# Access Compliance Report

## Public Rights-of-Way

### (Curb Ramps)

Intersection ID: 6114	Main Street: ATKINS_RIDGE_DR	Cross Street: HARTLEY_HILLS_DR	Location:	E
ADA ID: 6B0A0B0C9344	Ramp Type: Perp	Initial Pass/Fail: Fail	Overall Compliance: No	Severity Score: 12.5

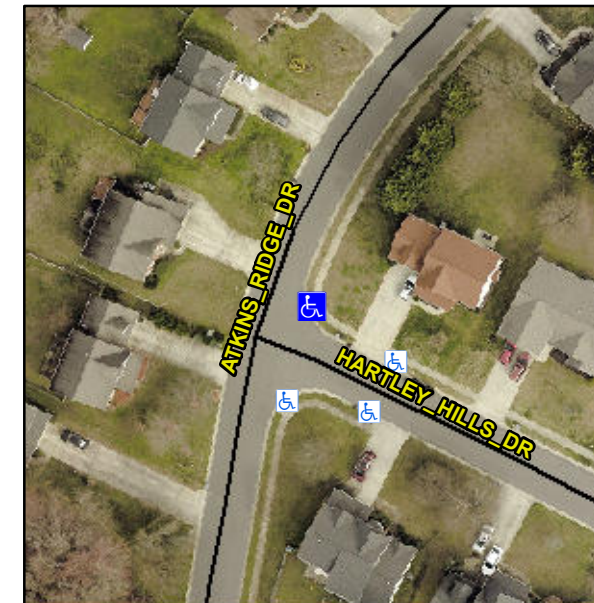
Compliance	Description	Data	Compliance	Description	Data
N/A	Ramp Length (in)	47.0	No	Ramp Slope (%)	10.3
Yes	Ramp Width (in)	48.1	Yes	Ramp XSlope (%)	1.1
N/A	Flare Type LT	N/A	N/A	Flare Type RT	N/A
N/A	Flare Slope LT (%)	N/A	N/A	Flare Slope RT (%)	N/A
N/A	Flare Traversable LT?	N/A	N/A	Flare Traversable RT?	N/A
N/A	Landing Length (in)	N/A	N/A	DWS Provided?	N/A
N/A	Landing Width (in)	N/A	N/A	DWS Contrast?	N/A
N/A	Landing Slope (%)	N/A	N/A	DWS Length (in)	N/A
N/A	Landing X Slope (%)	N/A	N/A	DWS Full Width?	N/A
N/A	Landing Curb? (Y/N)	N/A	N/A	DWS Offset (in)	N/A
N/A	Shared Landing?	N/A			
N/A	Gutter Ponding?	N/A	N/A	Gutter Slope (%)	N/A
N/A	Gutter Lip Ht (in)	1.0	N/A	Gutter X Slope (%)	N/A
N/A	Painted X Walk1?	No	N/A	Painted X Walk2?	N/A
	X Walk 1 Direction	To SW		X Walk 2 Direction	N/A
N/A	X Walk 1 Width (in)	N/A	N/A	X Walk 2 Width (in)	N/A
	X Walk 1 Slope (%)	1.8		X Walk 2 Slope (%)	N/A
	X Walk 1 X Slope (%)	1.3		X Walk 2 X Slope (%)	N/A

**Remove & Replace Entire Ramp.**

**R304.2.2**
